City of Franklin

Tuesday, October 8, 2019

4. [19-0920](#) PUBLIC HEARING: Consideration Of Resolution 2019-88, A Resolution Approving A Development Plan For Carothers Glen PUD Subdivision For The Property Located North Of South Carothers Road And East Of Surrey Lane, At 4338 & 4340 South Carothers Road. (FPMC 9/26/19 6-1; WS 10/8/19)

CAROTHERS GLEN PUD SUBDIVISION, DEVELOPMENT PLAN
 RESOLUTION 2019-88
 FRANKLIN MUNICIPAL PLANNING COMMISSION
 09/26/2019

Overall
Development
Plan

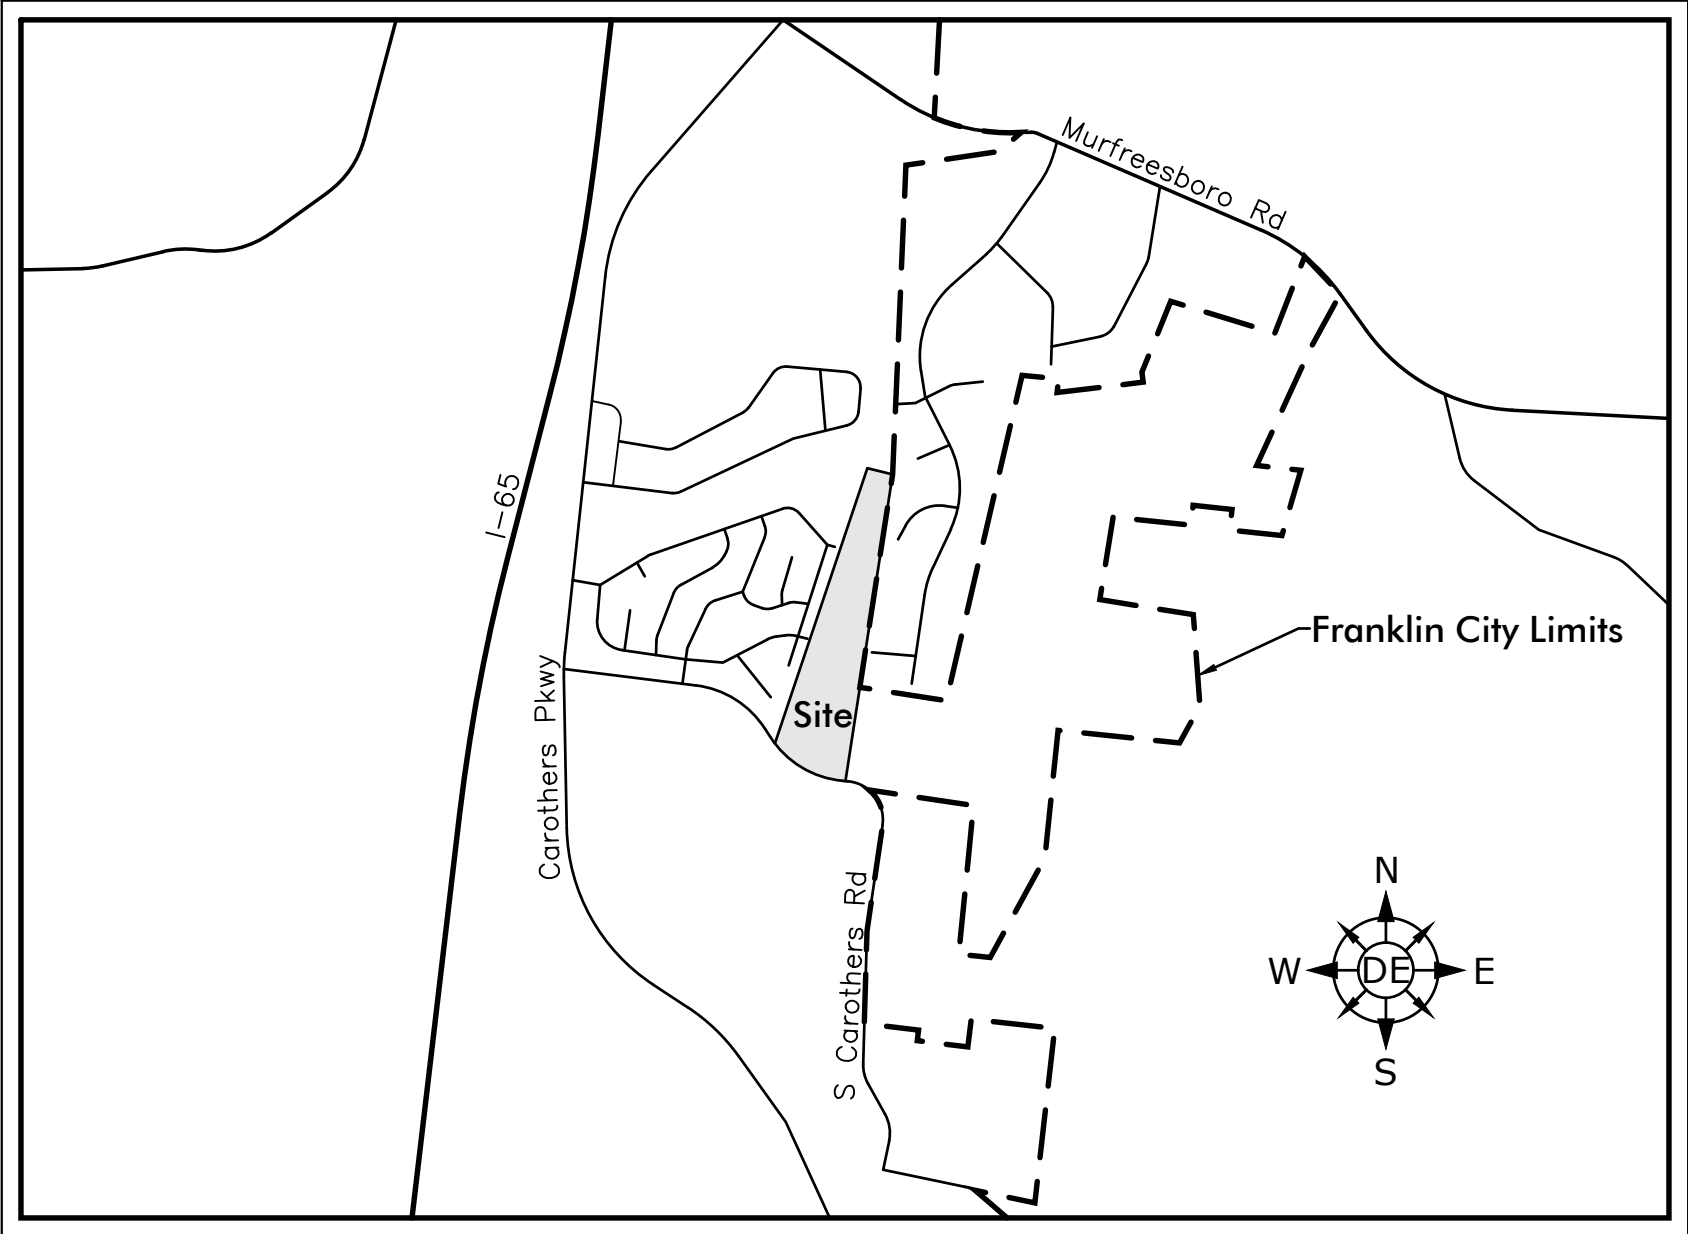
lance.fittro@franklintn.gov Applicant shall revise the note added on C2.0 to specifically reference Lots 2, 3, 19, 22, 23, 41 and 42, all of which are shown to have PUDAE's on the residential lot. Additionally, applicant shall identify these lots as Critical Lots for Public Infrastructure on the Development Plan, Site Plan and Final Plat.

At Site Plan stage, the applicant shall provide clear access to all stormwater BMP's. Any access easement provided to these areas which cannot be traversed by maintenance equipment shall not be acceptable.
